**ISSUE:** Certificate of Appropriateness for new construction

**APPLICANT:** City of Alexandria and Washington Metropolitan Area Transit Authority (WMATA)

**LOCATION:** Old and Historic Alexandria District  
2500 Potomac Greens Drive (2405, 2501, 3701 Potomac Avenue, 3251 Potomac Avenue [Parcel ID 016.04-01-01], 700 Carpenter Road, 1702 and 1880 Potomac Greens Drive) 2901 Potomac Avenue (2405, 2501, 3701 Potomac Avenue, 3251 Potomac Avenue [Parcel ID 016.04-01-01], 700 Carpenter Road, 1702 and 1880 Potomac Greens Drive)

The BAR has been reviewing this enormous project through an iterative, cumulative process. The applicant has requested approval of the following three items at this hearing. The remaining items will be brought forward on December 18, or whenever they are ready. Item numbers below reference a spreadsheet that the applicant has used at the past several hearings and is included in the linked staff report of October 16, 2019.

# Station Dark Skies Check

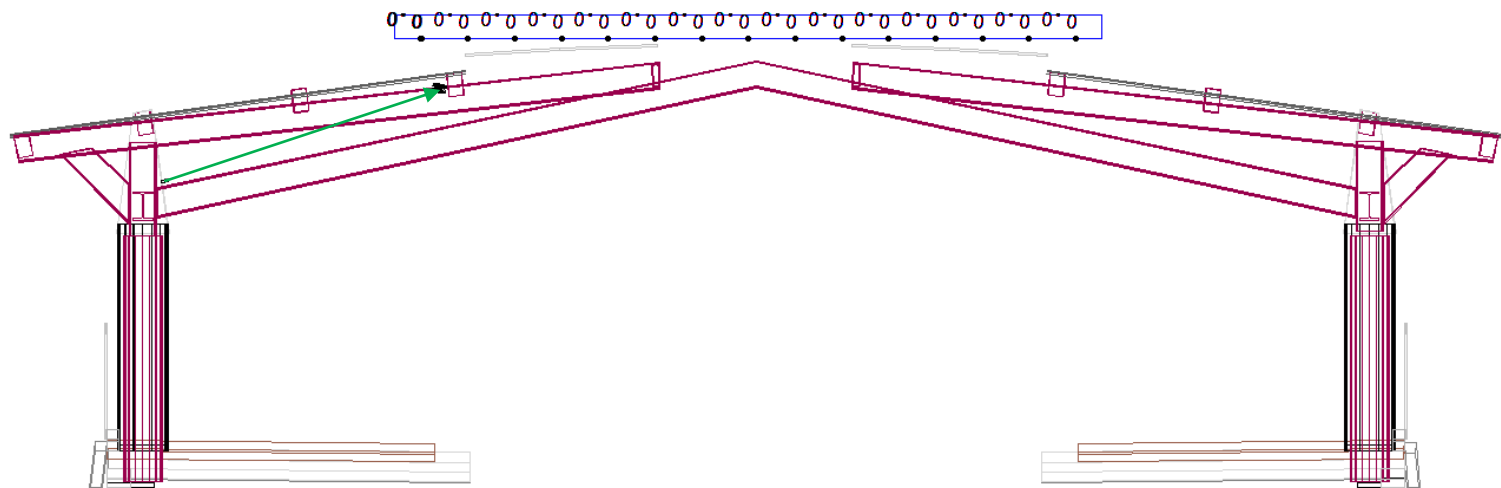
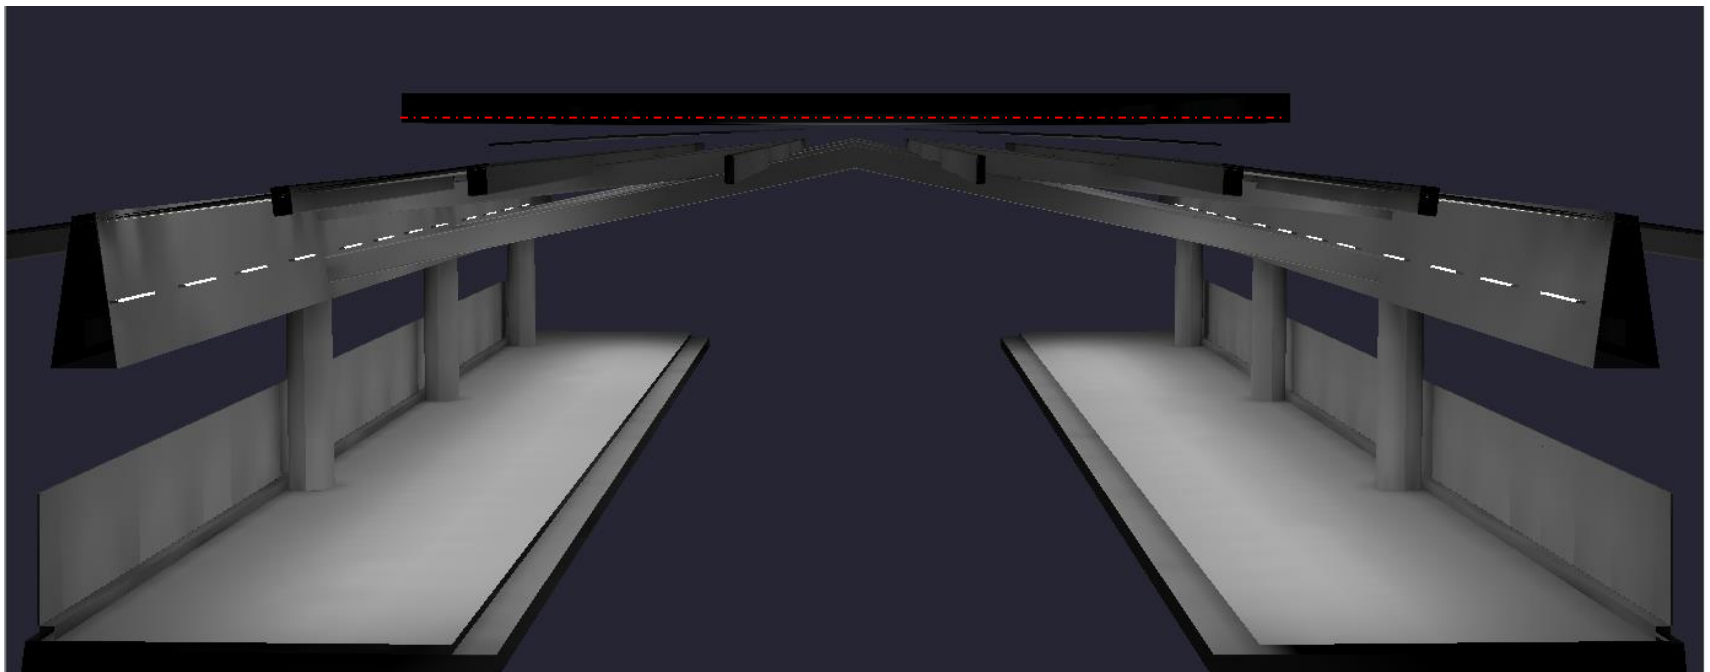
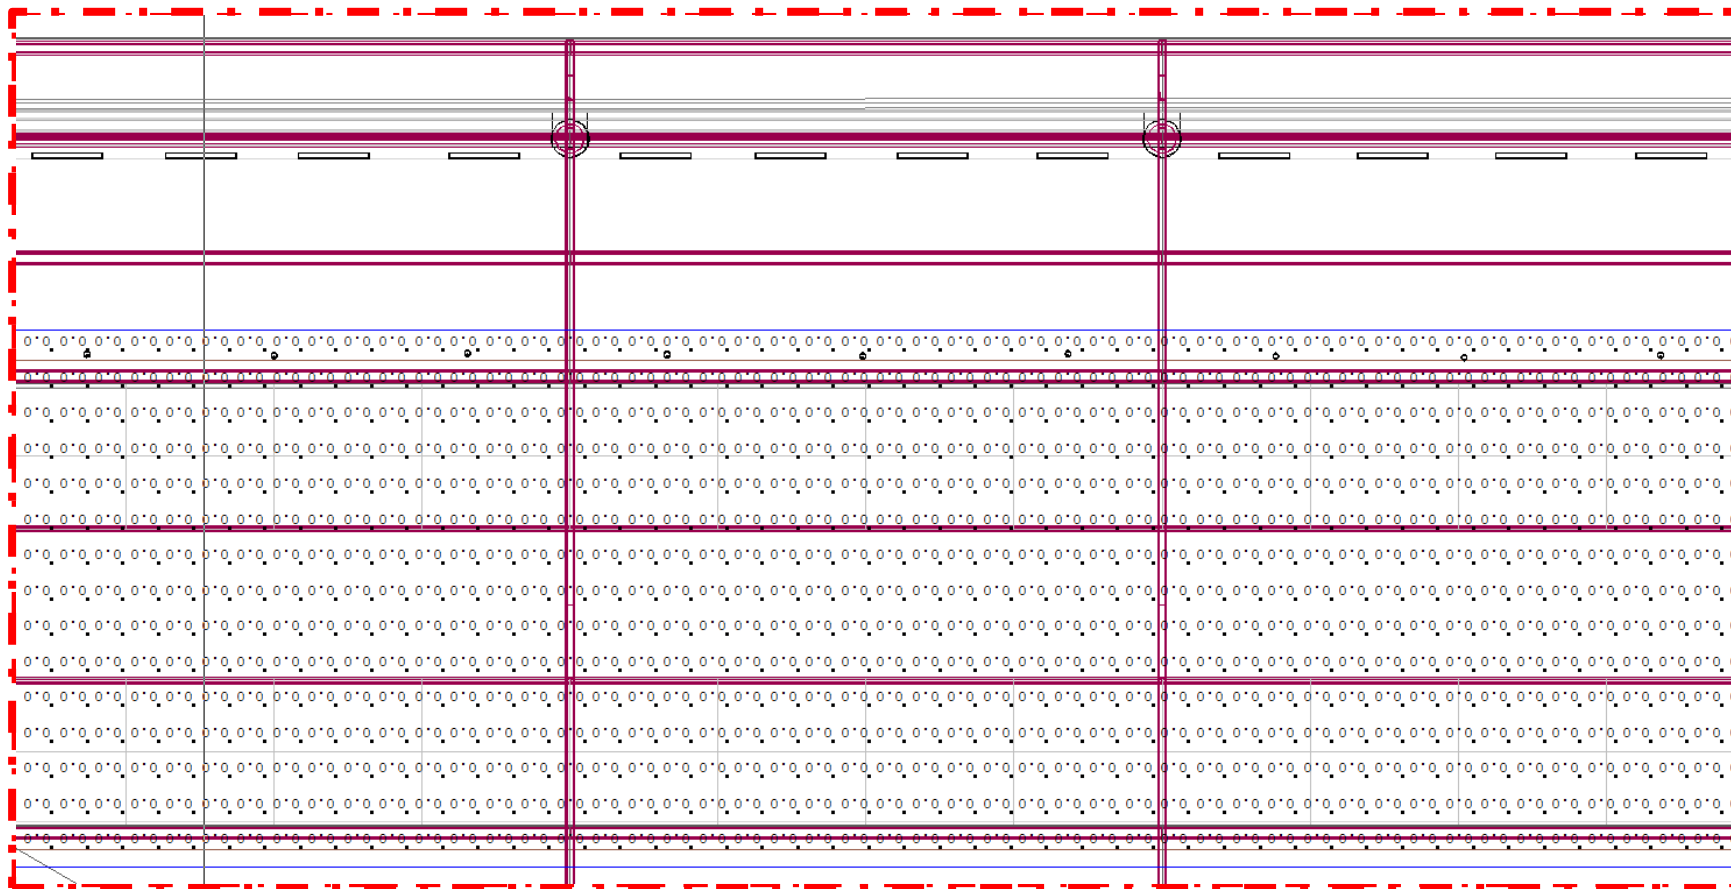
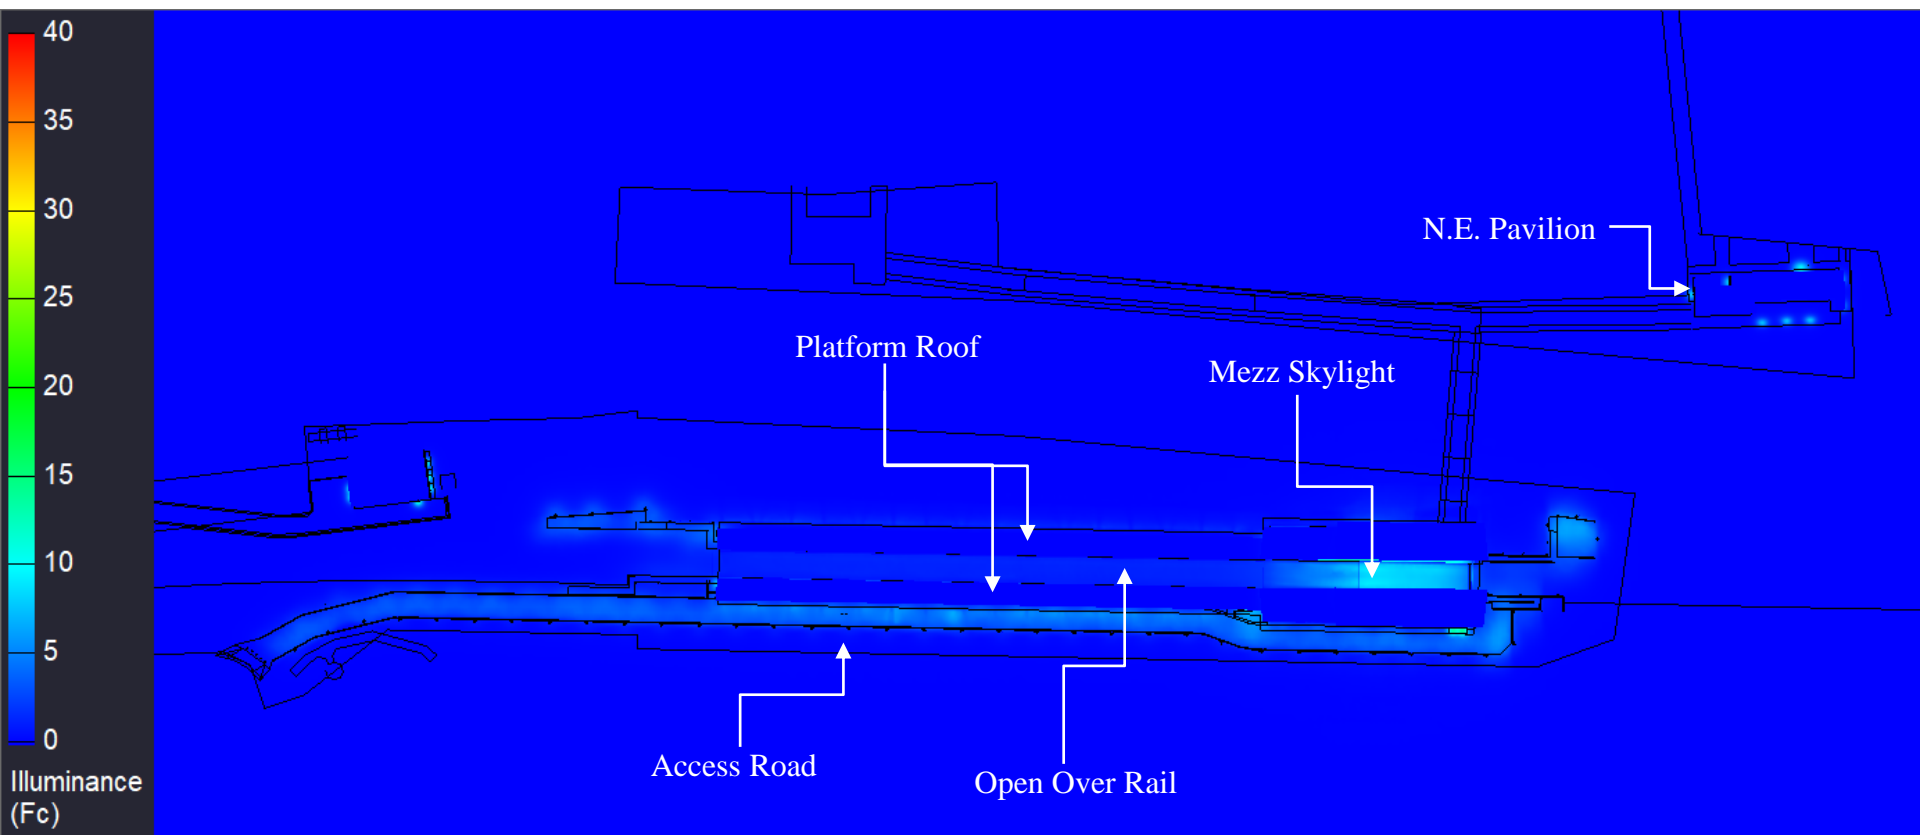
The BAR also asked for confirmation that the platform and mezzanine lighting would comply with the Dark-Sky recommendations of LEED. The design/build team has provided drawings to confirm that no light will be directed up through the skylight and will explain their renderings at the hearing.
